Author's note: This update incorporates the resolution of other comments related to 120G.3.4.1, which have been resolved or are in the initial bucket.

120G.3.4.1 Module stressed input test

Figure 120G-10—Example module stressed input test setup

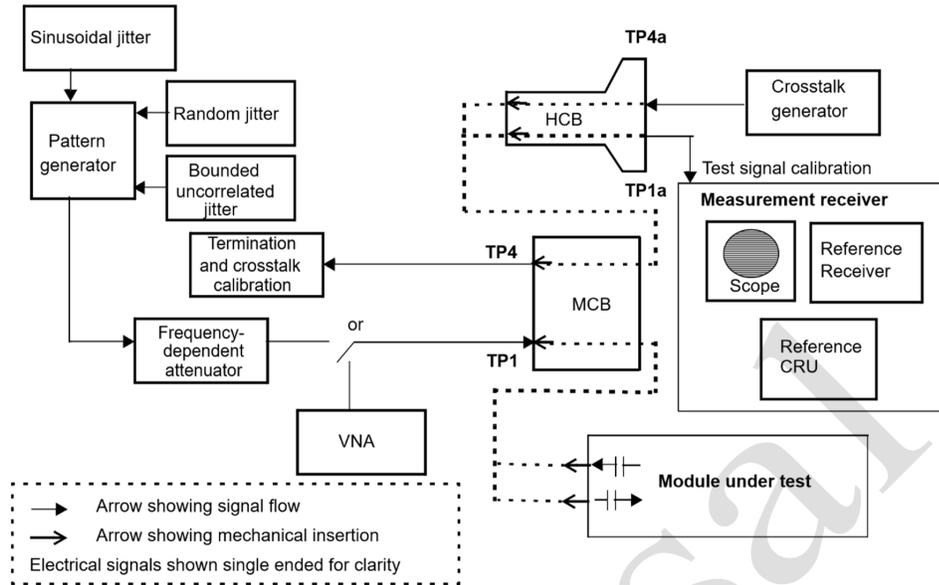
Commented [AR(4): Comment #131 (editorial change from response: “is used to calibrate the stressed signal using a PRBS13Q pattern” moved to the calibration subclause)

Commented [AR(5): Comment #140

The module stressed input test setup is illustrated in Figure 120G–10. The stressed signal is applied at TP1 and is calibrated at TP1a.

A crosstalk generator for counter-propagating signals representing the module output is used for calibration of the stress. The counter-propagating signals are asynchronous to the pattern generator. This crosstalk generator is not present in the test, being replaced by the output of the module under test.

The measurement receiver has a reference clock recovery unit (CRU) that acts as a high-pass jitter filter with a 3 dB corner frequency of 4 MHz and slope of 20 dB/decade.

The test system meets the ERL specification given in 120G.3.1.2 when measured at TP1a.
